# UNITED STATES PATENT AND TRADEMARK OFFICE

APPLICATION NO.	FILING DATE	FIRST NAMED INVENTOR	ATTORNEY DOCKET NO.	CONFIRMATION NO.
10/560,832	02/28/2007	Takeshi Kamata	050826	7411
23850 7590 07/16/2010 KRATZ, QUINTOS & HANSON, LLP 1420 K Street, N.W. 4th Floor WASHINGTON, DC 20005				
EXAMINER				
HILTON, ALBERT				
ART UNIT		PAPER NUMBER		
1716				
MAIL DATE		DELIVERY MODE		
07/16/2010		PAPER

### Office Action Summary

### DETAILED ACTION

Diagram 1, reproduced with modification from Moen, Fig. 2.

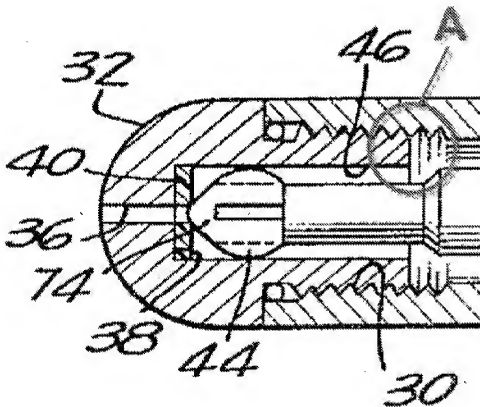
3. Regarding claim 1, Moen describes a nozzle (**liquid dispenser 10**) comprising a receiver (**spool 56**); a first nozzle part (**barrel 22**) formed in a cylindrical shape, the first nozzle part (**22**) communicating with the receiver (**56**), the first nozzle part (**22**) being coaxial with and separate from the receiver (**56**); and a second nozzle part (**tip insert**

32) formed in a cylindrical shape having an inner diameter smaller than that of the first nozzle part (22), and an outer diameter equal to that of the first nozzle part (22), the second nozzle part (32) being connected to the first nozzle part (22), wherein the second nozzle part (32) is disposed nearer to the coating object than the first nozzle part (22), and wherein between the first (22) and second (32) nozzle parts there is formed a step (see A in diagram 1 below) protruding from the inner surface of inwardly between the first nozzle part (22) toward the inside of and the second nozzle part (32) (Moen: column 4, lines 8-10, 33-35, and Fig. 2).

4. Further regarding claim 1, the first **(22)** and second **(32)** nozzle parts are not always in open communication with each other, as the connection between the two is sometimes blocked by a conical valve obturator **(74)** when the valve is in an opened position (Moen: column 5, lines 4-24 and Figs. 6, 10). Moen teaches that such a valve system functions to interrupt the flow of material and to prevent adhesive material dispensed from the nozzle from setting inside the nozzle.

5. However, the elimination of an element and its function does not distinguish a claimed invention from the prior art where said function is not desired (see MPEP 2144.04: Elimination of a Step or an Element and its Function). One of ordinary skill in the art at the time of the invention, desiring to use the nozzle of Moen to dispense a continuous flow of material, would therefore have found it obvious to remove the obturator **(74)**, with the ordinary and expected result that such a modification would allow for an uninterrupted flow of material.

6. Regarding claim 2, the step **(A)** is formed flat in a direction crossing at right angles in a direction in which the dispensed fluid flows in the first **(22)** and second **(32)** nozzle parts.

7. Regarding claim 3, the step **(A)** in the nozzle of Moen is formed flat in a direction crossing both a direction in which the dispensed fluid flows in the first **(22)** and second **(32)** nozzle parts and a direction crossing at right angles the direction in which the fluid flows.

8. Regarding claim 4, the step **(A)** in the nozzle of Moen is formed on the first nozzle part **(22)**.
9. Regarding claim 5, the first **(22)** and second **(32)** nozzle parts in the nozzle of Moen are connected coaxially with each other.

10. Regarding claims 6-8, Moen discloses a nozzle (**liquid dispenser 10**) comprising a first (**barrel 22**) and a second (**tip insert 32**) part (Moen: column 4, lines 8-10, and Fig. 2). Moen does not specify the precise ratio of the length (**L**) of the first part **(22)** to the length (**l**) of the second **(32)** part. However, the use of a first part **(22)** of length **L** and a second part **(32)** of length **l** such that  $8 \leq L/l \leq 10$  represents a mere change in the shape and proportion of the parts that would not alter the function of the nozzle in a patentably distinct way over the prior art (see MPEP 2141.01). One of ordinary skill in the art at the time of the invention would find it obvious that nozzles with a broad variety of different length ratios could be created. Similarly, while Moen does not disclose the precise ratio of the diameter (**D**) of the first part **(22)** to the diameter (**d**) of the second **(32)** part, one of ordinary skill in the art would have found it obvious that nozzles satisfying the condition  $4 \leq D/d \leq 6$  could be used, as well as nozzles that simultaneously satisfy the conditions  $8 \leq L/l \leq 10$  and  $4 \leq D/d \leq 6$  without altering the function of the nozzle in a patentably distinct way over the prior art.
